CHILDREN'S HOSPITAL
OF ORANGE COUNTY

TOWER II

SECOND FLOOR INTERIOR
ELEVATIONS

A9.2E

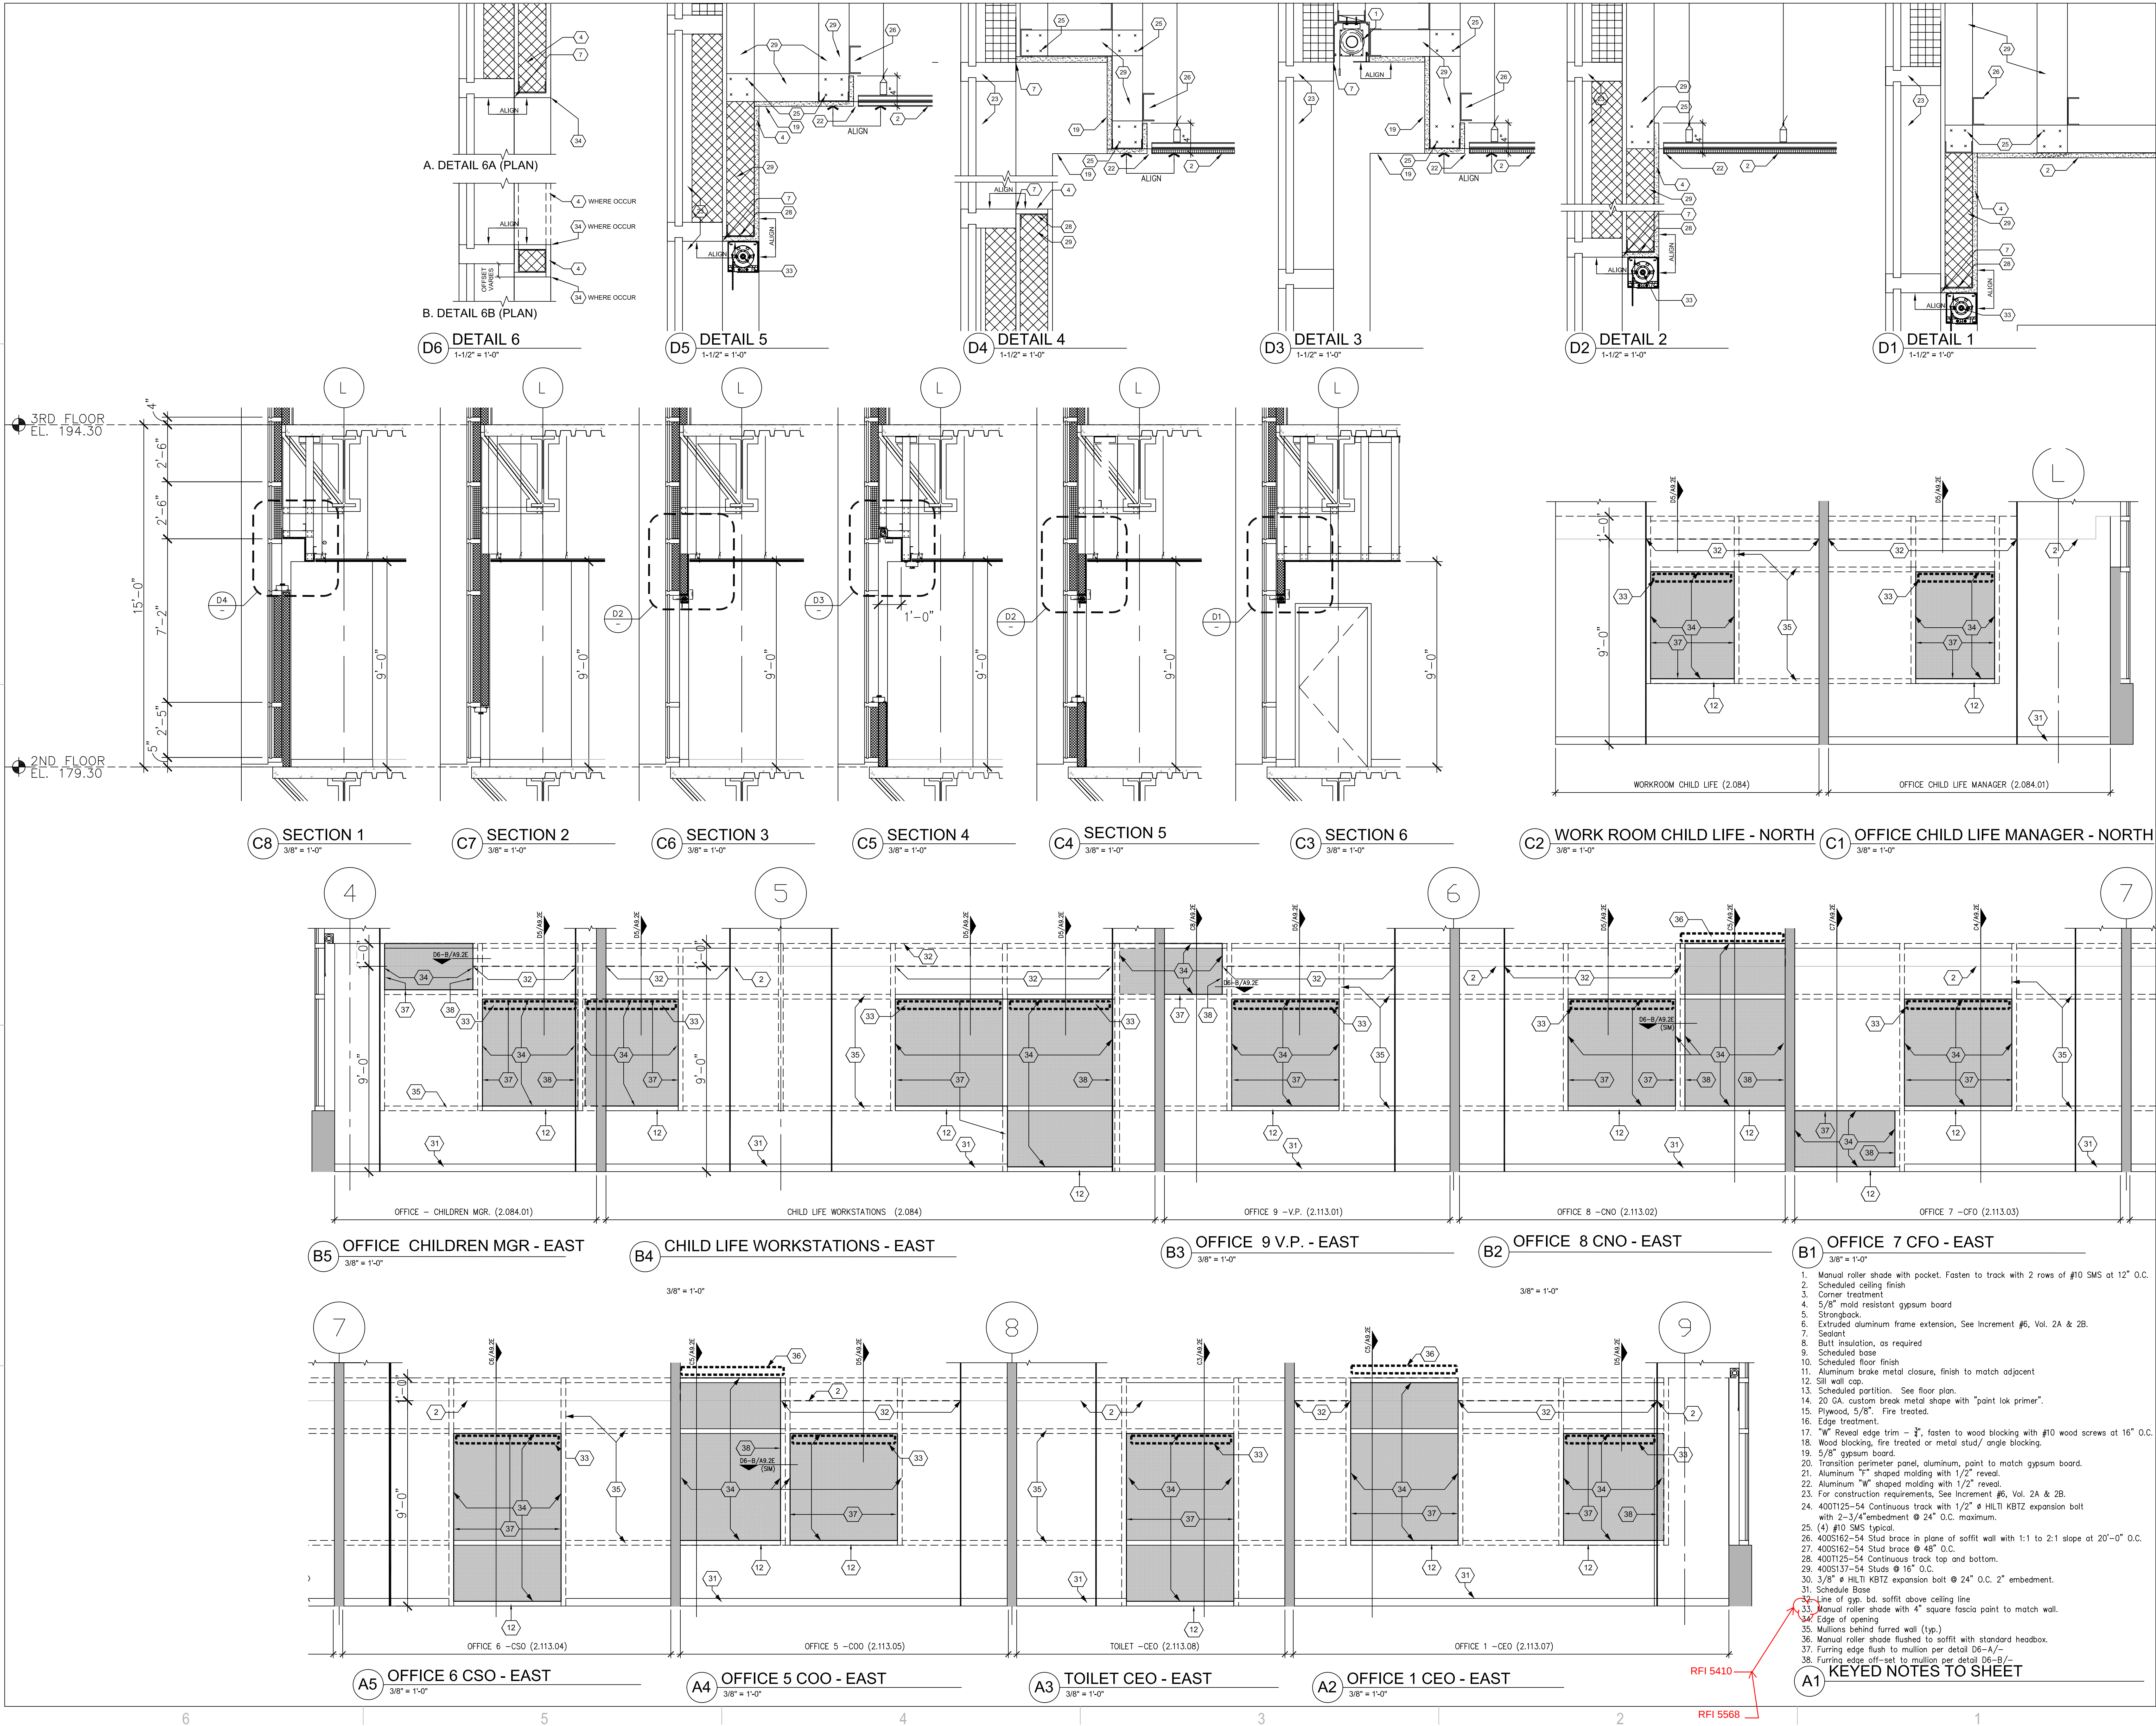
110 01/09/12 ASI #158

RFI 5410

RFI 5568
